**DATE:** November 22, 2022  
**TO:** Planning and Sustainability Commission  
**FROM:** Jeff Caudill, Environmental Planner  
**cc:** Patricia Diefenderfer, Sallie Edmunds  
**SUBJECT:** Floodplain Resilience Plan Work Session #2 Memo

**Decision Table 1: Staff Proposed Amendments to the Proposed Draft**

# Floodplain Resilience Plan

Proposed Amendment A-1: Replacement for Map 6 in the document

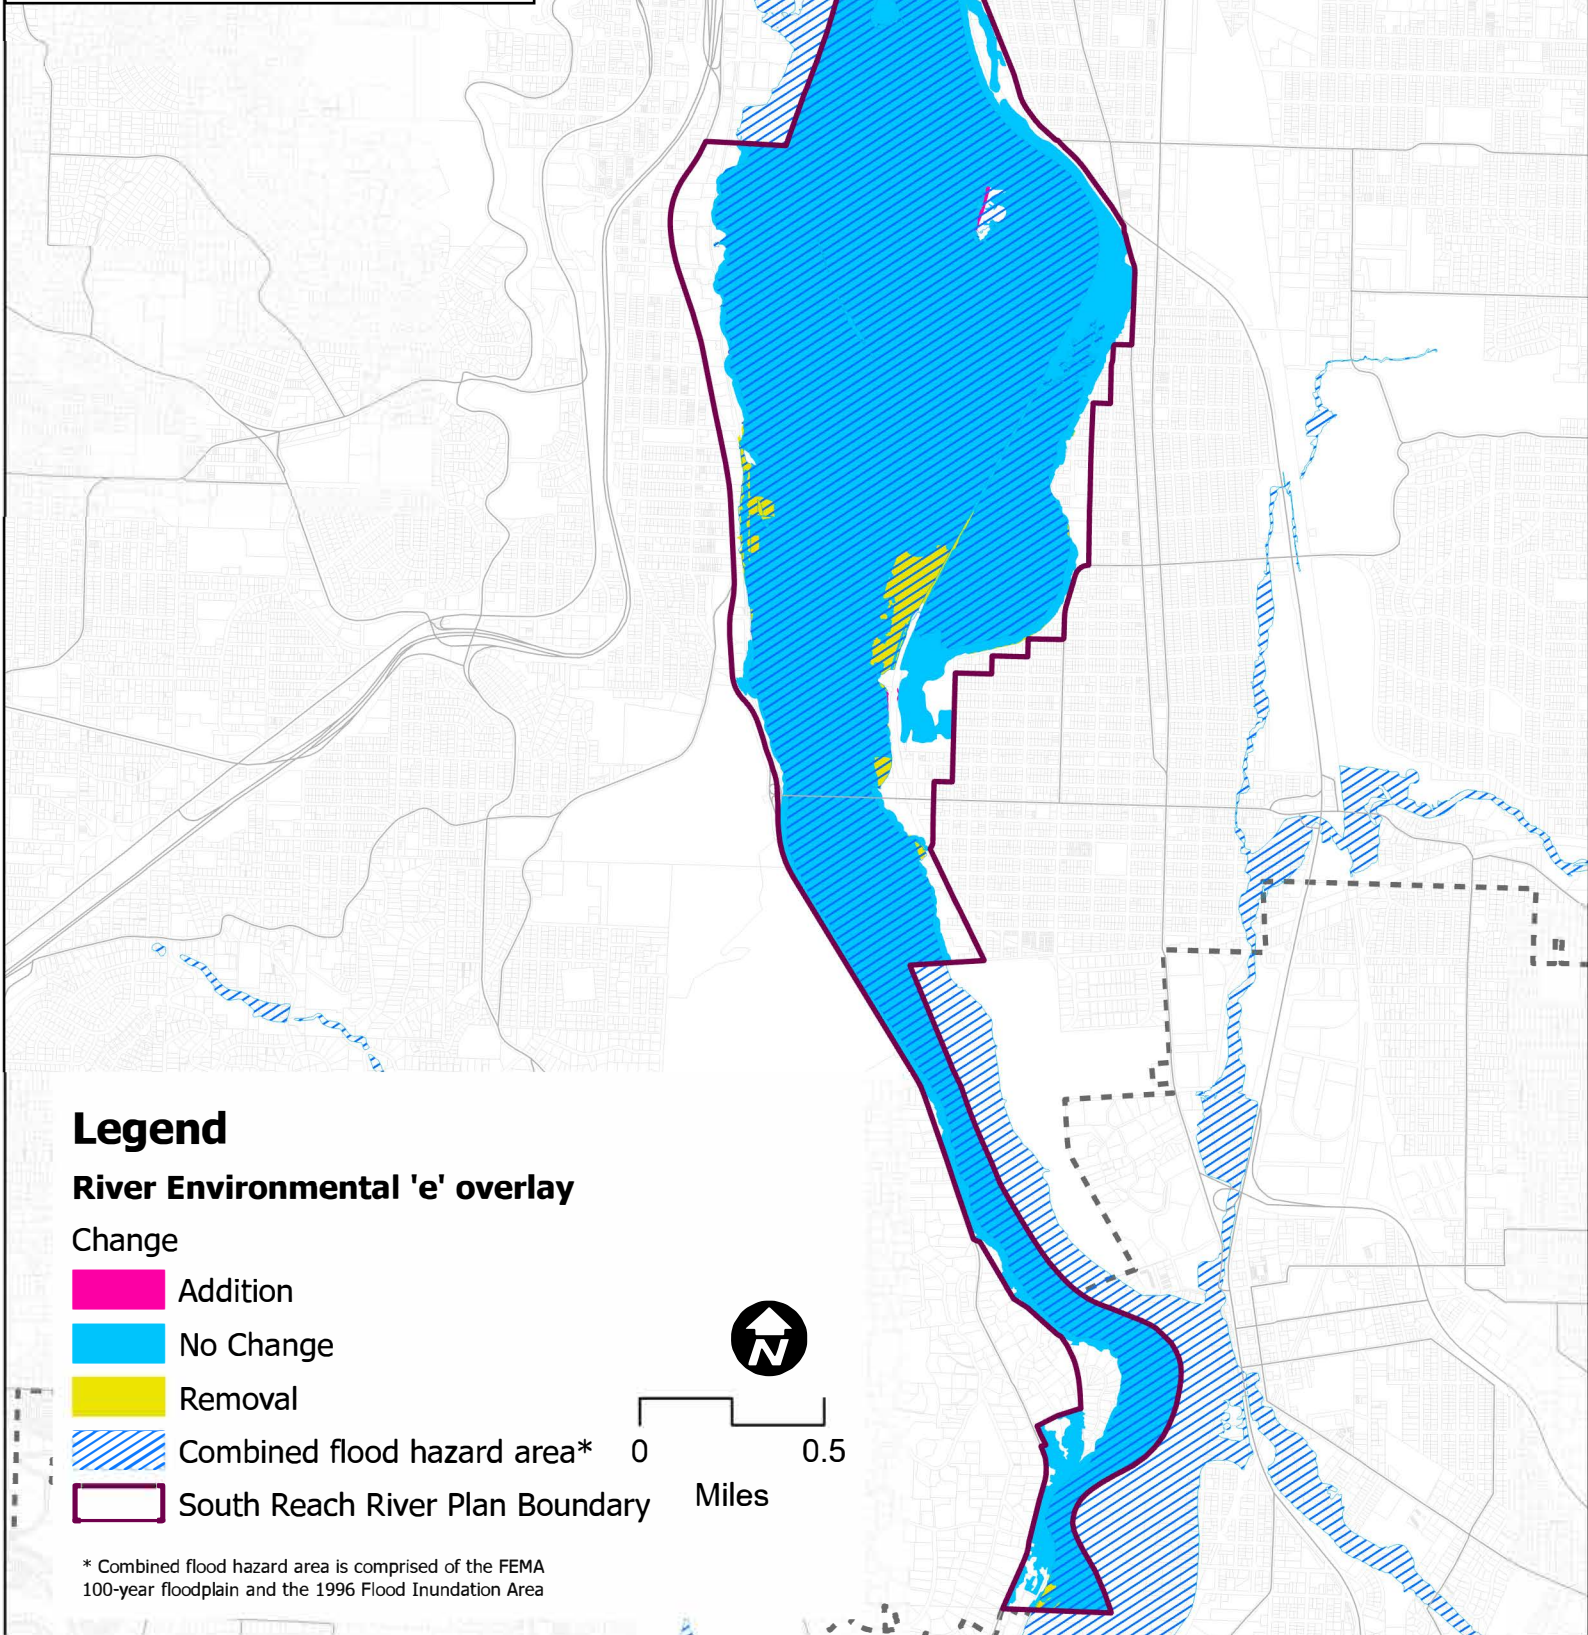
Ref #	Comment	Commenter(s)	Topic	Comment or Requested Amendment	Staff recommendation	Staff rationale	Discuss?	PSC decision
<b>MAP AMENDMENTS</b>								
<i>Amendment to Map 6, Proposed changes to the River Environmental Overlay Zone in the Willamette River South Reach</i>								
A-1	N/A	BPS Staff	Proposed South Reach River Environmental overlay zone	Modify the extent of the proposed River Environmental to apply it to the river setback, land within 100 feet of the top of bank, and all high- and medium-ranked riparian resources.	Replace Map 6, Proposed changes to the River Environmental Overlay Zone in the Willamette River South Reach, on page 52 of the Proposed Draft with the replacement Map 6 shown in the collection of maps in Decision Table A - Attachment 1.	The proposed River Environmental overlay in the Proposed Draft inadvertently removed some medium-ranked riparian resources that were not in the combined flood hazard area.	<input type="checkbox"/>	<input type="checkbox"/> Support staff rec. <input type="checkbox"/> Other

Proposed Amendment A-3: Modify proposed River Environmental overlay zone and riparian buffer area

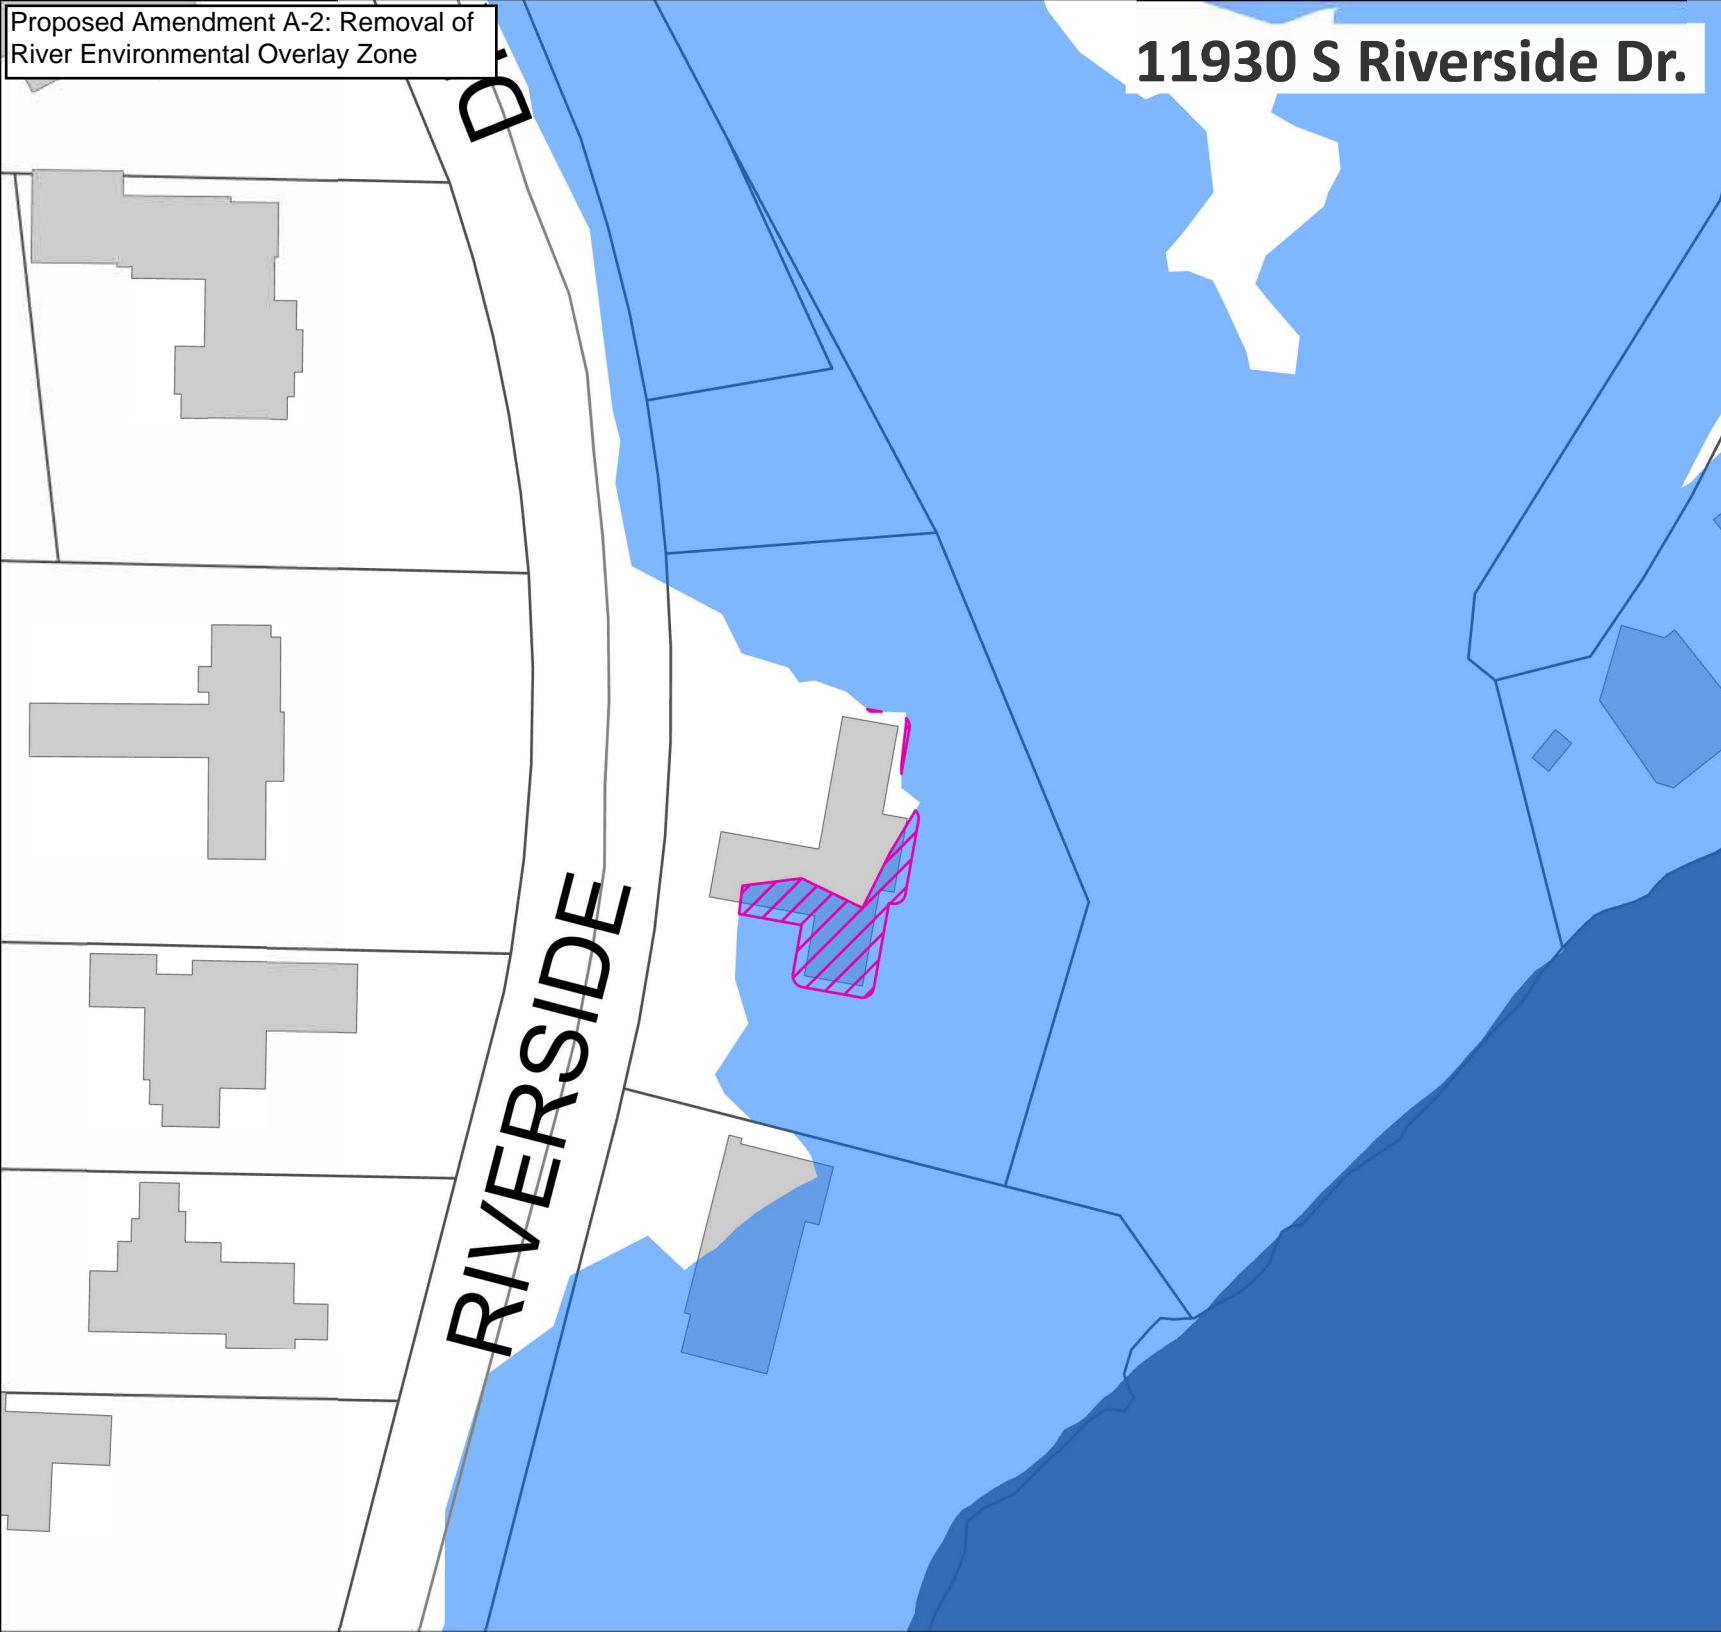
A-3	Call with BPS staff	Jim Kurtshaw	Modification of the proposed River Environmental overlay zone and riparian buffer area on Riverfront Place Condominiums site (NW Riverscape St)	Property owner at 1736 NW Riverscape St contacted City staff to request that the River Environmental overlay zone and riparian buffer area proposals be reevaluated because, as a part of the Riverscape development (around 2010), the site was removed from the FEMA 100-year floodplain through a FEMA Letter of Map Amendment based on the site characteristics.	Remove the property from the combined flood hazard area, as the FEMA 100-year floodplain is the only flood map relevant to the site (the Modeled Willamette River 1996 Flood Extent does not extend onto the property).  With this modification of the combined flood hazard area, remove the proposed expansion of the River Environmental overlay zone and application of the riparian buffer area on the site.  See the modification to the proposed River Environmental and riparian buffer area for this site in the collection of maps in Decision Table A - Attachment 1.	City staff determined that the property had been removed from the FEMA 100-year floodplain through a Letter of Map Amendment and the property should not be considered as a part of the combined flood hazard area. Therefore, the proposed expansion of the River Environmental overlay zone and application of the riparian buffer area on the site is not warranted.	<input type="checkbox"/>	<input type="checkbox"/> Support staff rec. <input type="checkbox"/> Other

**Figure 510-2**  
**South Waterfront Greenway Setback Area and Subareas**

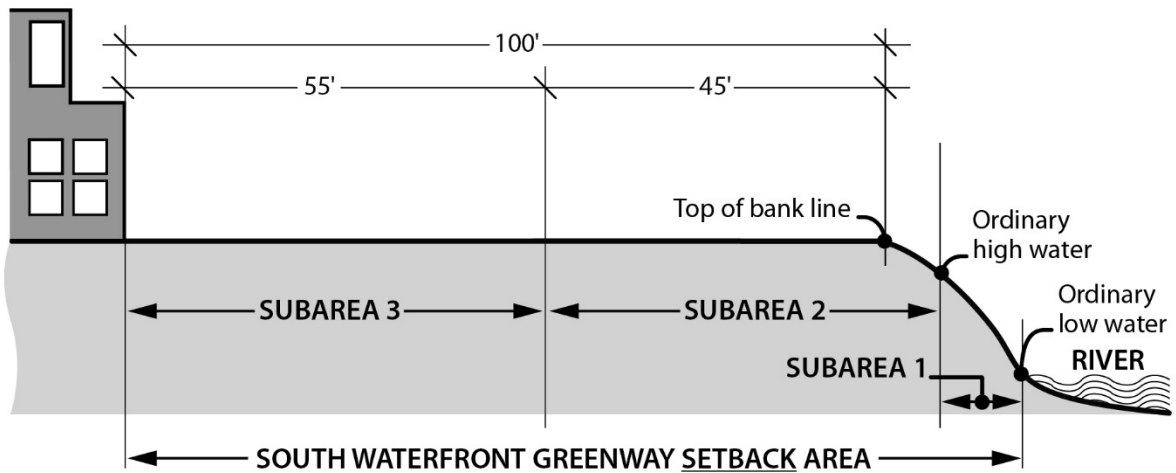
<i>Technical Amendments &amp; Clarifications</i>								
A-11	332079	BDS Staff	Update Figure 510-2 in the South Waterfront Subdistrict (33.510.253.)	The text in Figure 510-2 should be updated throughout to include “South Waterfront Greenway <u>Setback</u> Area” throughout.	<p>Update Figure 510-2 to incorporate “setback” into the figure’s text where the “Greenway Area” is identified.</p> <p>For more detail, see all of the staff proposed code amendments in Decision Table A - Attachment 2.</p>	Not including “setback” was an oversight. It should be included in Figure 510-2.	<input type="checkbox"/>	<input type="checkbox"/> Support staff rec. <input type="checkbox"/> Other

Greenway Setback Area = from ordinary low water to 100' from top of bank line  
Subarea 1 = from ordinary low water to ordinary high water  
Subarea 2 = from ordinary high water to 45' in from top of bank line  
Subarea 3 = from 45' in from top of bank to 100' in from top of bank line
